Treasure Hill

Building Heights and Fill Comments

Arnie Rusten, PE, SE

11/29/2017

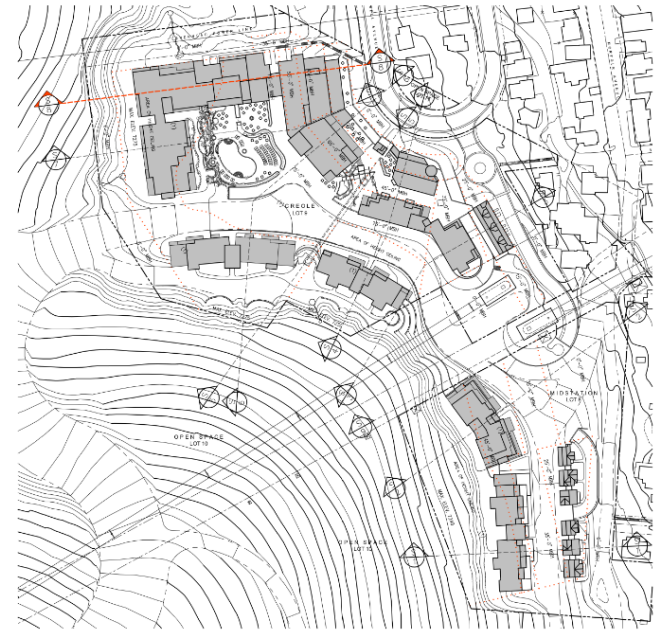
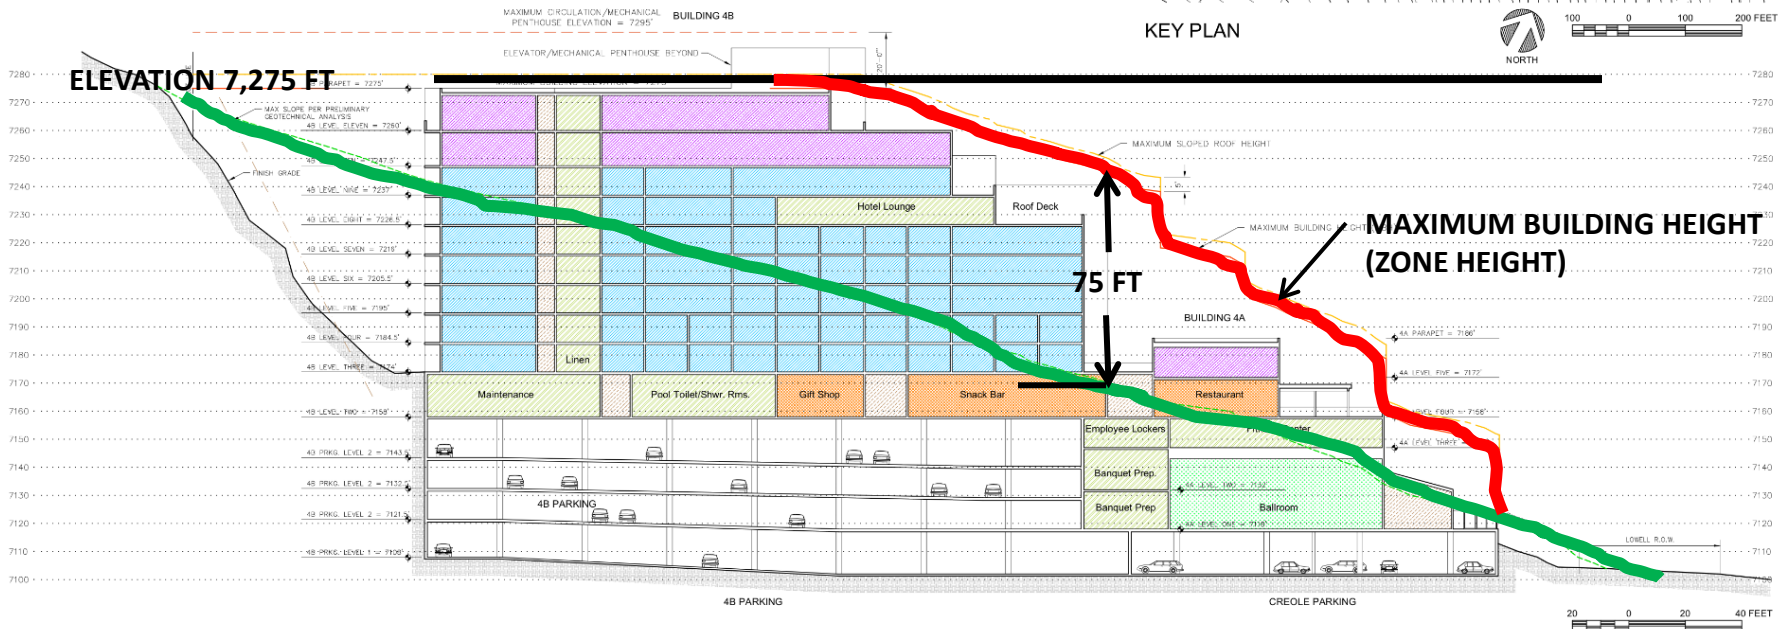
**PER PCMC LMC:
 ZONE HR-1
 MAXIMUM BUILDING HEIGHT 27 FT (ZONE HEIGHT)
 MAXIMUM STRUCTURE HEIGHT 35 FT**

**APPLICANT VARIANCE:
 ZONE HR-1
 MAXIMUM BUILDING HEIGHT 75 FT (ZONE HEIGHT)
 MAXIMUM STRUCTURE HEIGHT 83 FT (35 FT + 48 FT)**

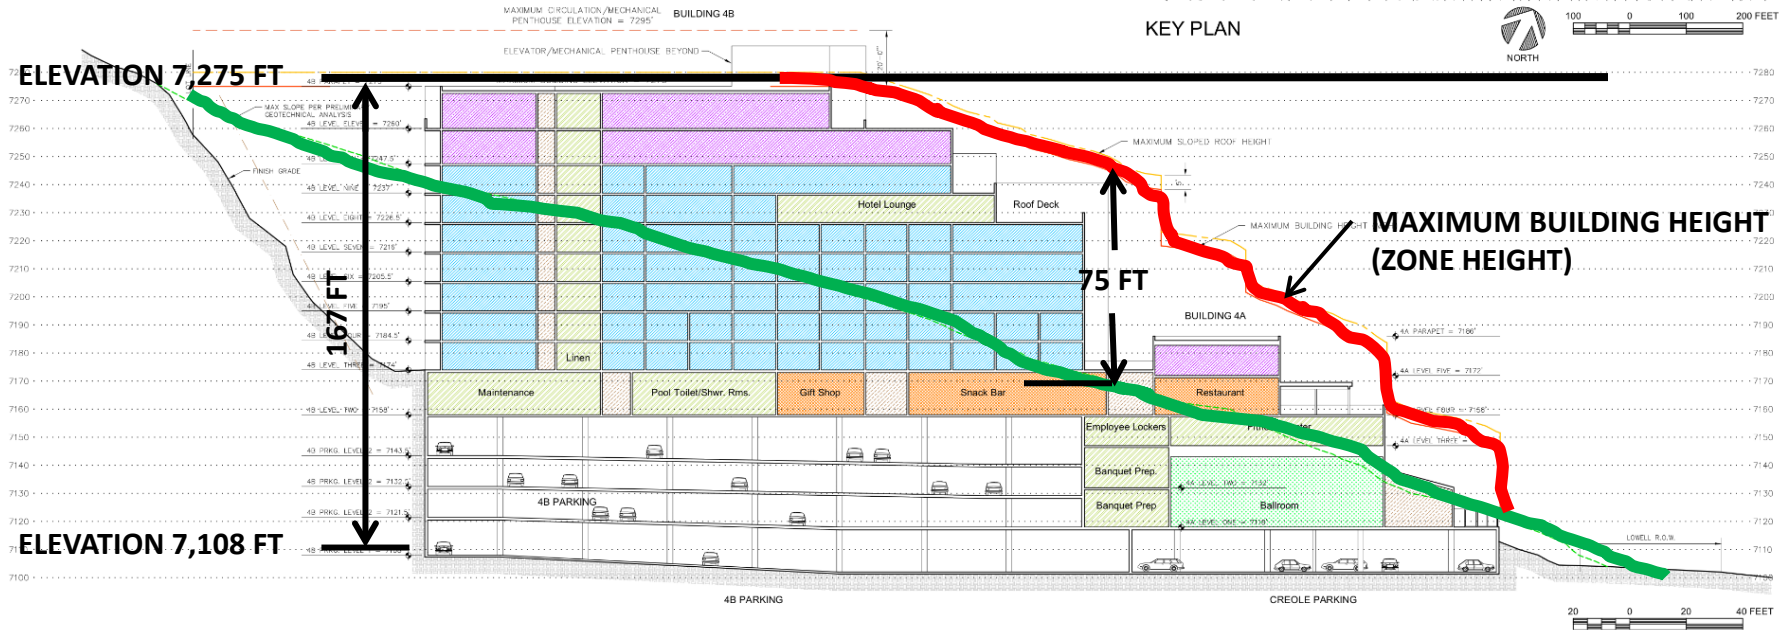
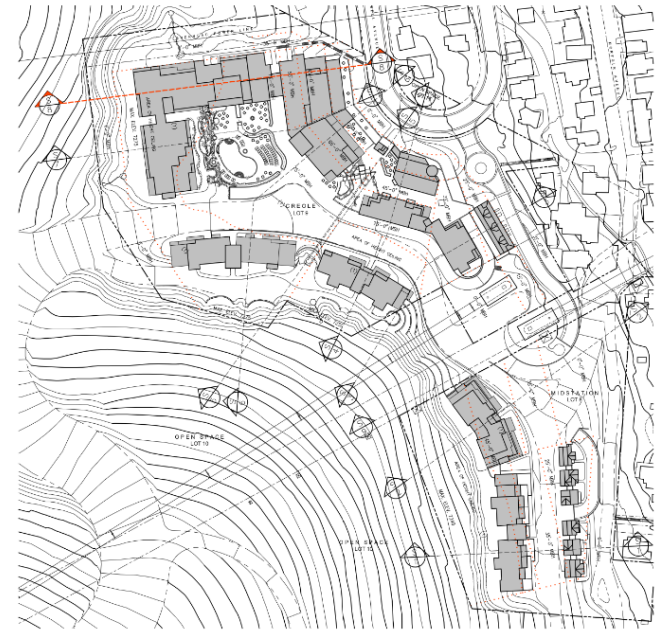
PER PCMC LMC:
ZONE HR-1
MAXIMUM BUILDING HEIGHT 27 FT (ZONE HEIGHT)
MAXIMUM STRUCTURE HEIGHT 35 FT

APPLICANT VARIANCE:
ZONE HR-1
MAXIMUM BUILDING HEIGHT 75 FT (ZONE HEIGHT)
MAXIMUM STRUCTURE HEIGHT 83 FT (35 FT + 48 FT)

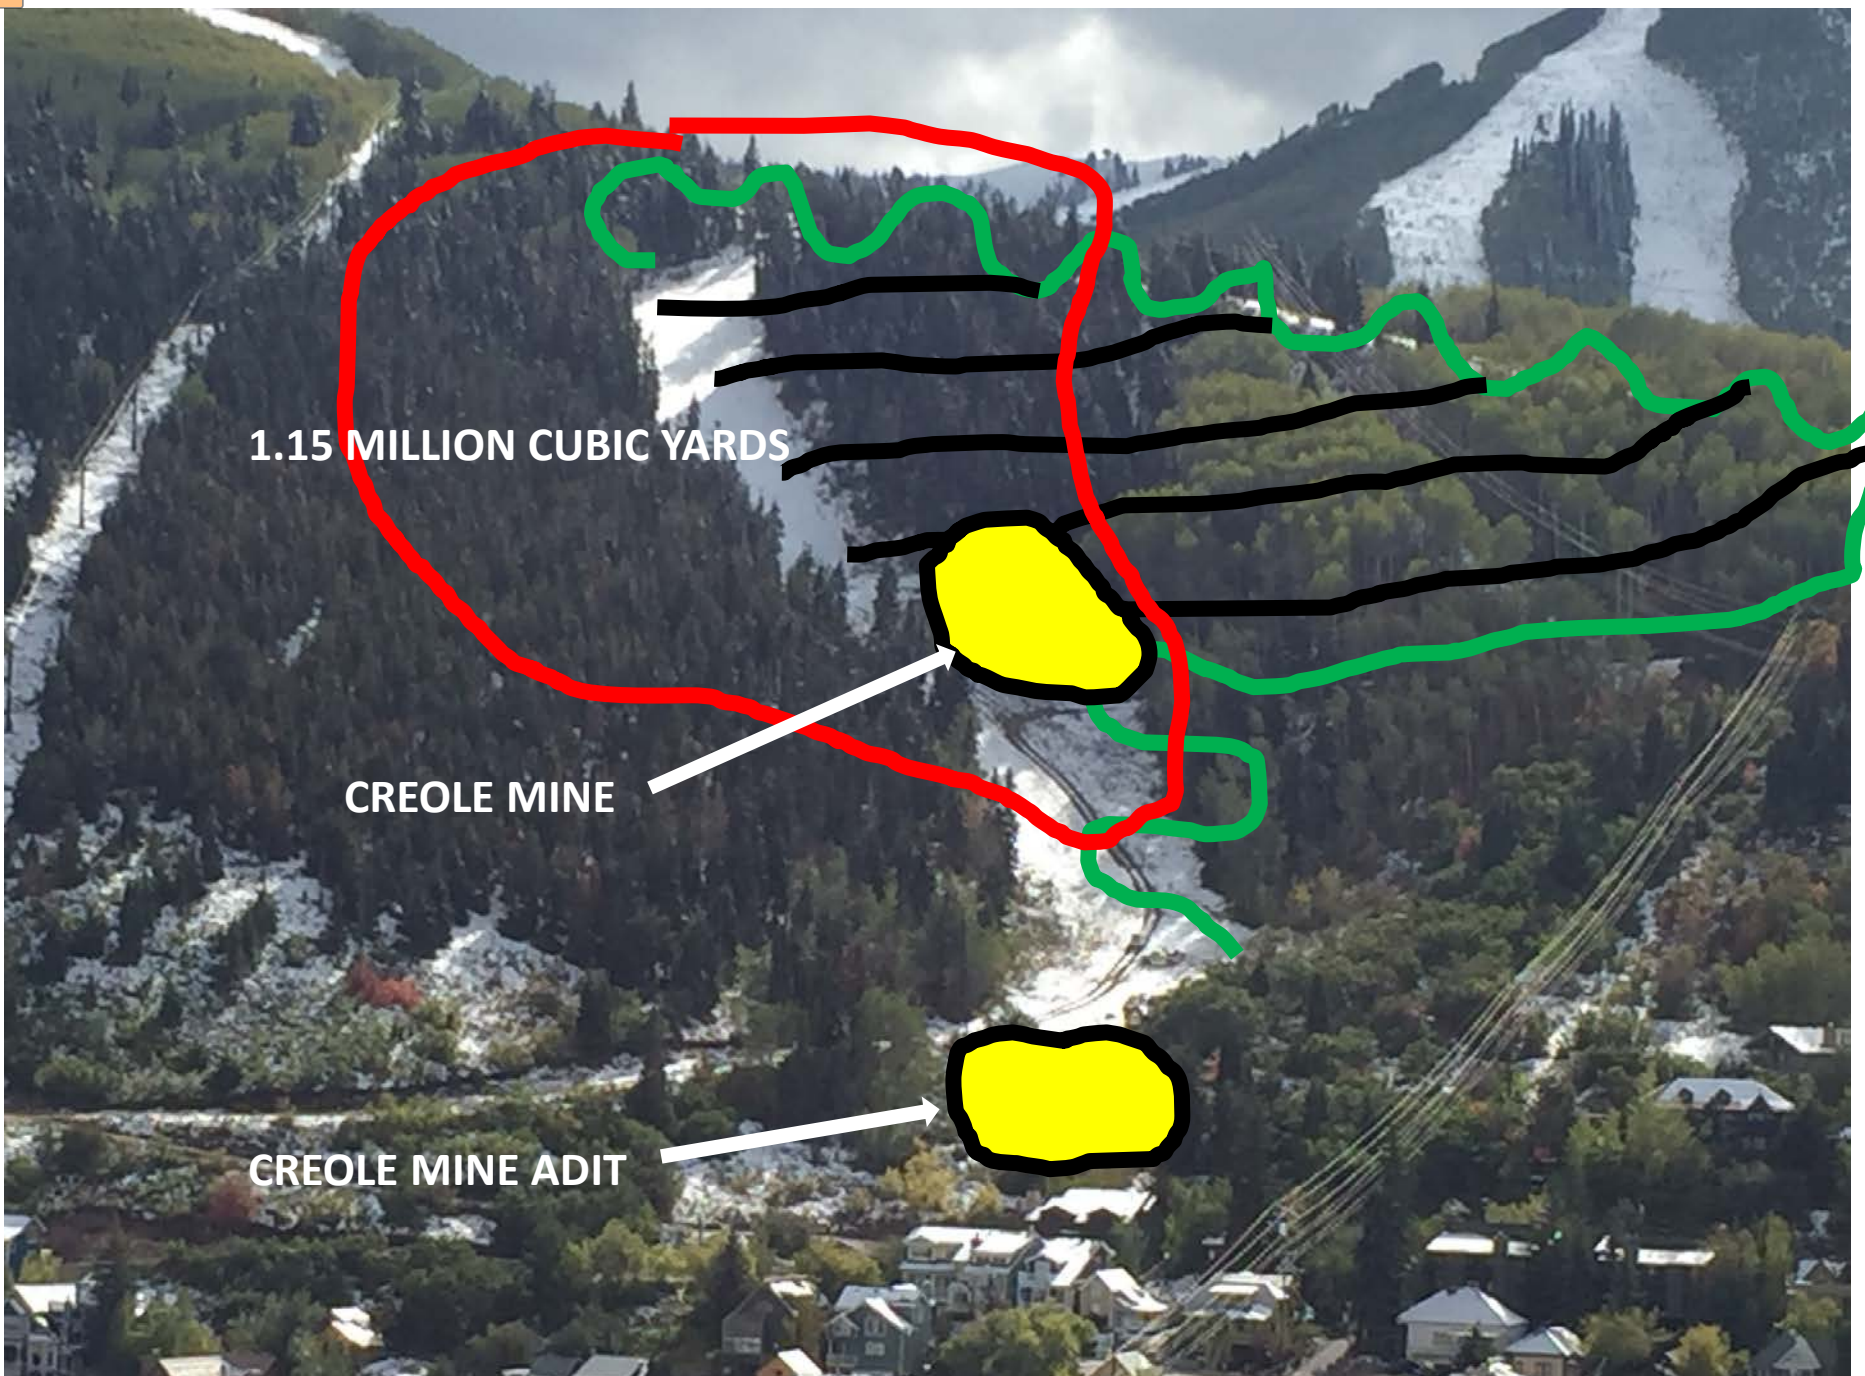
1.15 MILLION CUBIC YARDS

- **REMOVE ALL TREES AND VEGETATION**
- **REMOVE OVERBURDEN SOIL LAYER (OVER 22 FT DEEP AT THE CREOLE SKI RUN)**
- **STOCKPILE SUITABLE OVERBURDEN (WHERE, HOW)**
- **DISPOSE OF UNSUITABLE OVERBURDEN (WHERE, HOW)**
- **DISPOSE OF CONTAMINATED MATERIAL (WHERE, HOW)**
- **CONSTRUCT ACCESS ROADS**
- **PLACE ROCK FILL**
- **PLACE OVERBURDEN AND REVEGETATE**

CREOLE SKI RUN

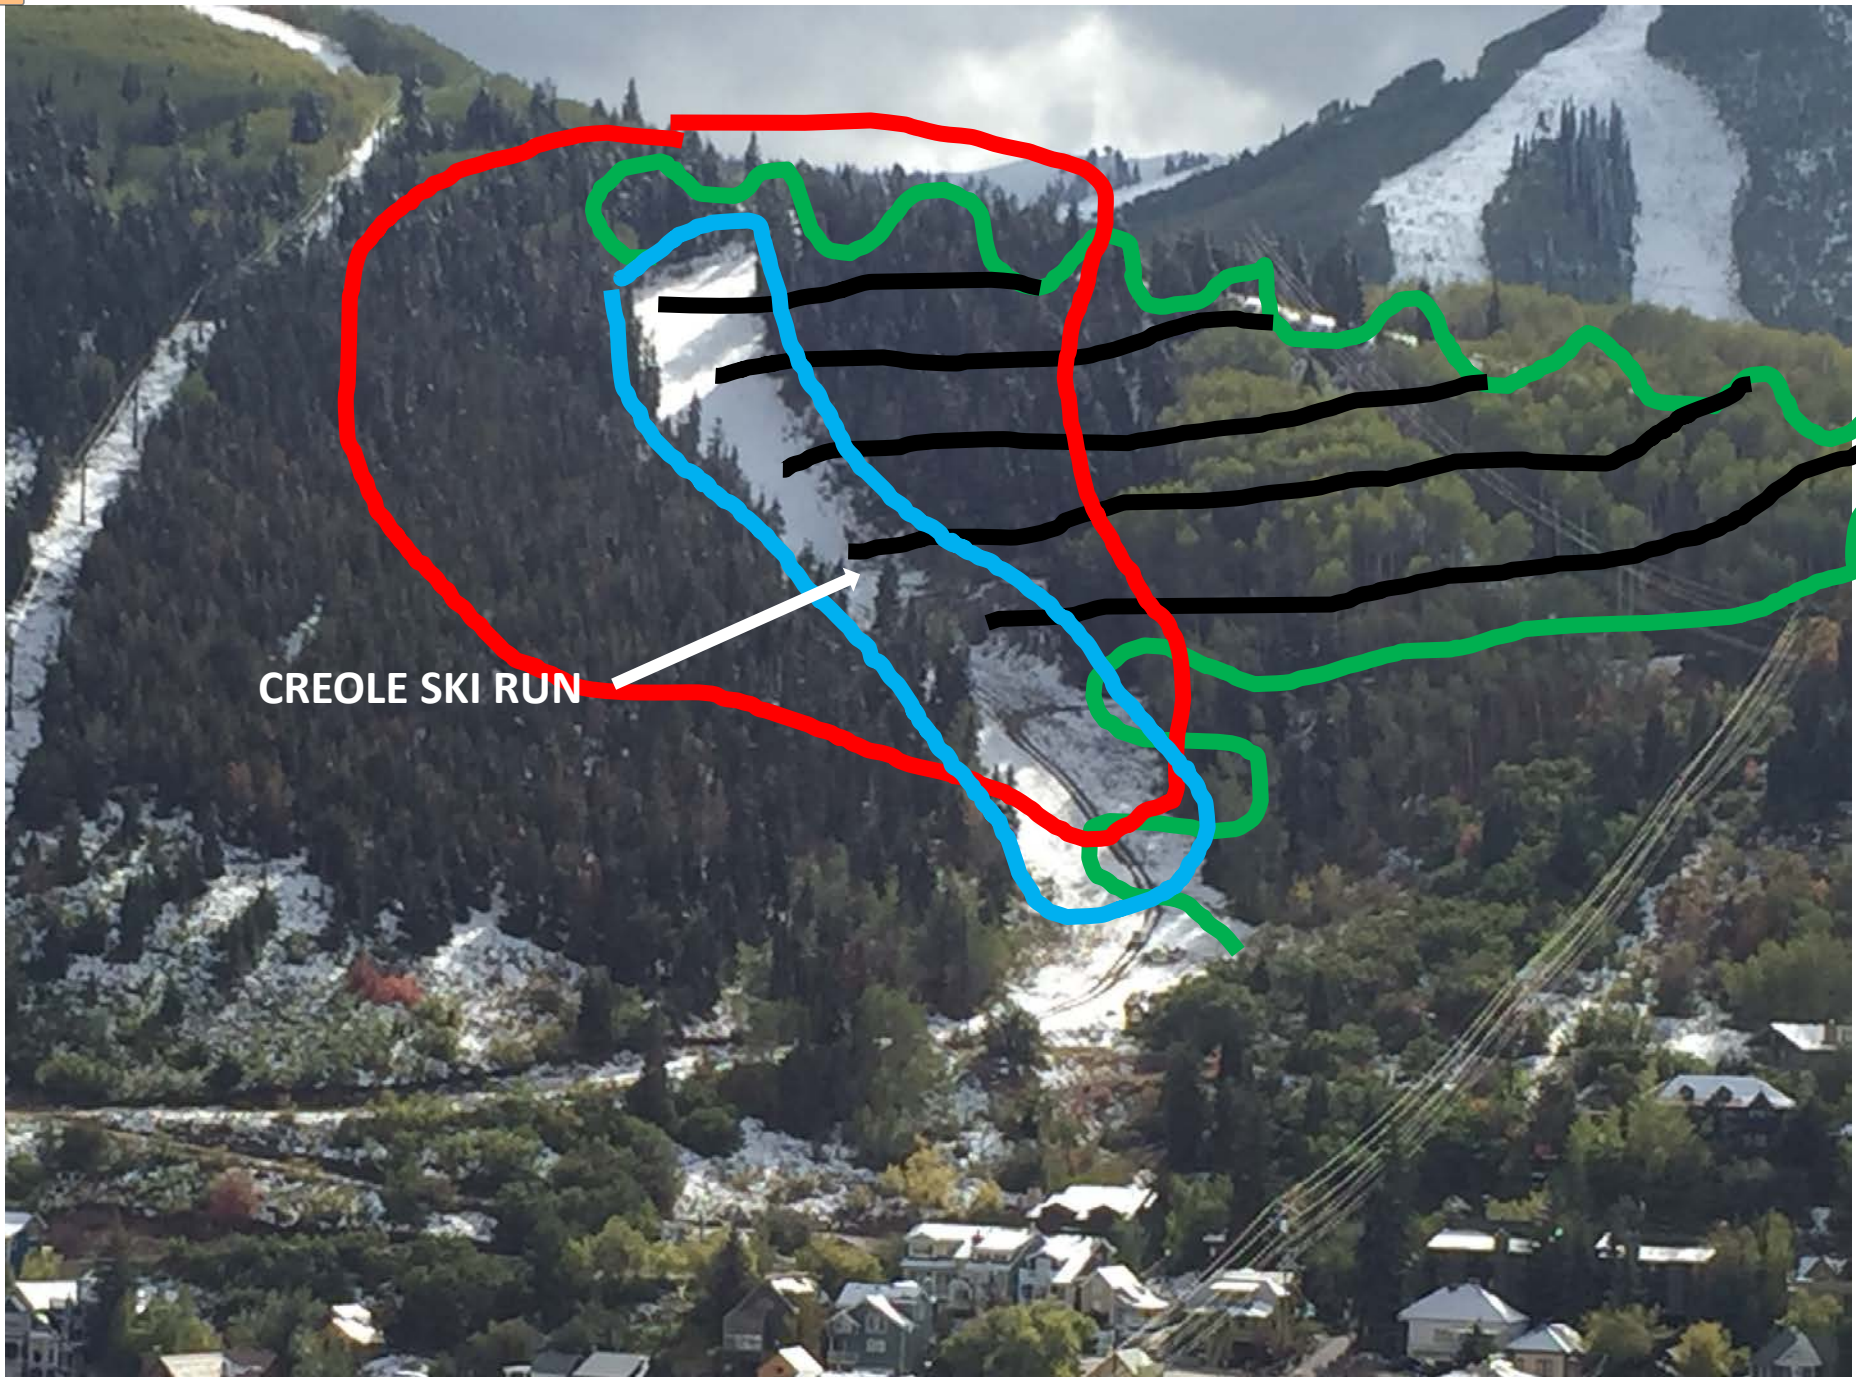
We understand that the excavated material from the midstation and Creole lots is proposed to be deposited uphill to the southwest, and that the majority of the fill placement is currently proposed to be in the upper portion of the Creole drainage. The fill is planned to be placed up to an approximate elevation of 130 feet above the current elevation.

Due to the manner of construction of the Creole ski run, a significant amount of fill has been placed in the bottom of the drainage. At the location of test pit TP-1, the fill extends to a depth of at least 22 feet, which is the maximum depth investigated in this area. The locations where fill is proposed to be placed should be cleared of topsoil, debris, fill and other deleterious materials prior to the placement of additional fill.

Due to the substantial slope existing on the Creole ski run, the base of the cleared areas should be stepped in order to provide stability for the body of fill and give a flat working platform for compaction. A qualified geotechnical engineer should observe the clearing of topsoil and fill prior to placement of fill in these areas.
